AGENDA - TROY PLANNING COMMISSION MEETING
WEDNESDAY, SEPTEMBER 18, 2024, 3:30 P.M.
CITY HALL, COUNCIL CHAMBERS

MEMORANDUM

SUBJECT: Record Plan – Somerset Reserve Section 1

SUBJECT: Certificate of Appropriateness – 112-118 W. Main Street

Front Façade: Present

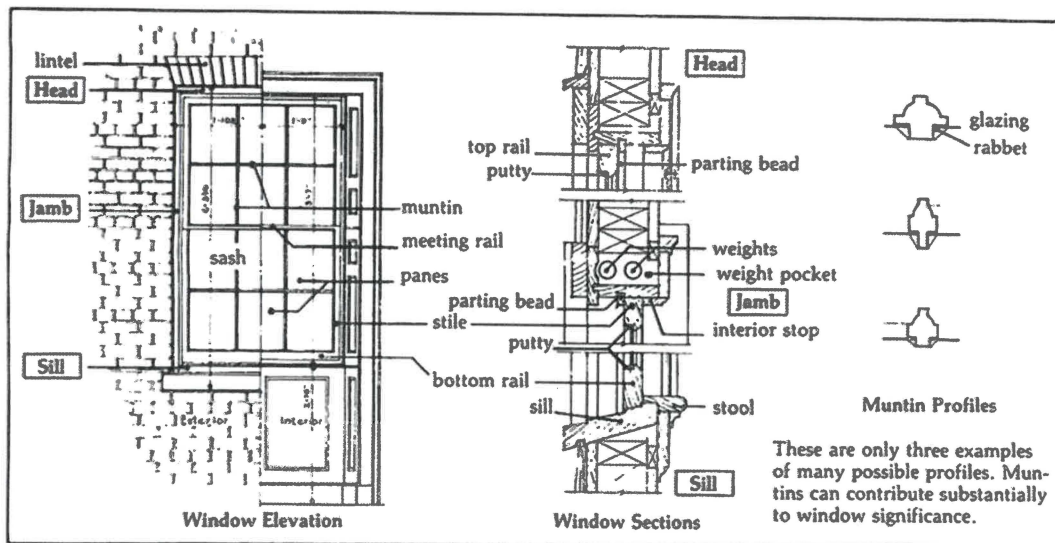
The 1902 portion of the building (three-story portion) includes twenty (20) windows with significant features in the arches, panes, and material. The third story on the front façade has four (4) prominent arched windows with two (2) smaller accent arches. Nine (9) over six (6) divided lights are present in the main arched window. The accent arches are one (1) over one (1) double hung windows. The second-floor windows are one (1) over one (1) double hung windows with accent double hung windows in between. The dynamic size of the second-floor windows makes these windows significant in comparison to the third-floor arched windows. The Applicant explained that due to the wave of the glass, it is likely that the windows are extremely old or original. A door opening is present on the fire escape on the south side of the 1902 building. The following pictures are from previous dates due to the windows being currently boarded up:

Window Replacements: The applicant is proposing the replacement of all the second and third floor windows on the 1902 building with Pella reserve Wood Windows wrapped in black aluminum. The number of muntins will match the original windows. On the 1840 building, the applicant is proposing six (6) over six (6) pane window replacements with the Pella Reserve Wood windows wrapped in black aluminum. A total of nine (9) windows are proposed for replacement on the 1840 building and twenty (20) on the 1902 building.

- Per Design Manual Section 2.8 B: Clear evidence was not supplied by the applicant that illustrates extensive deterioration is present on the second and third floor windows on the front and rear facades. Additionally, clear evidence was not provided that the windows cannot be repaired, even at significant cost.
- Per Design Manual Section 2.8 D: The application does not provide information on the dimensions and profile of the original window sash and muntins.

#8: The front (north) elevation of the IOOF building in June 2024, after stabilization repairs. THPA proposes to replace the windows on the second and third floors of this north elevation with high-quality wood windows made of like materials.

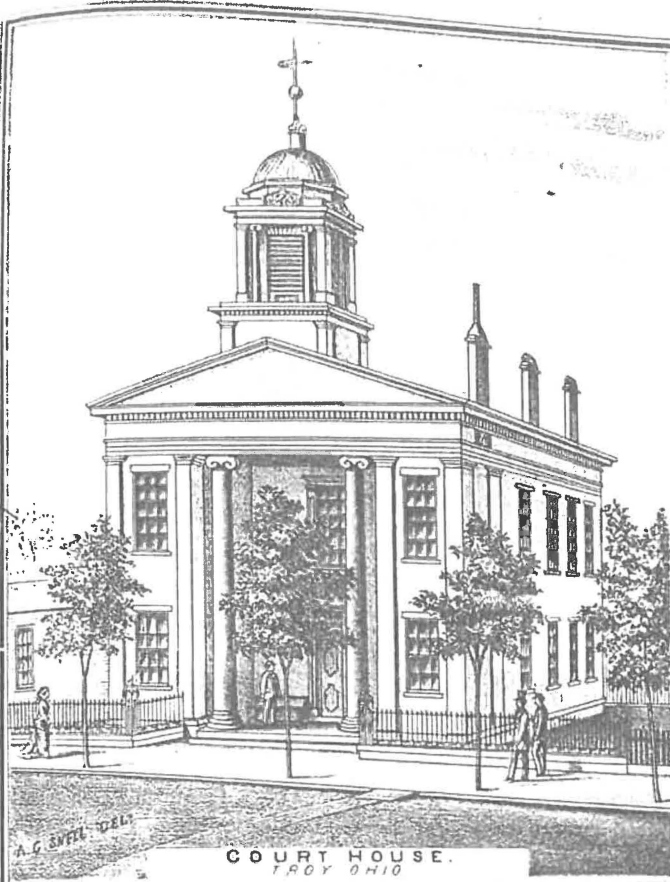
#9: The second and third floor windows on the south elevation of the IOOF building and west and south sides of the old courthouse, as shown in this photo, would be replaced with high-quality wood windows made of like materials.
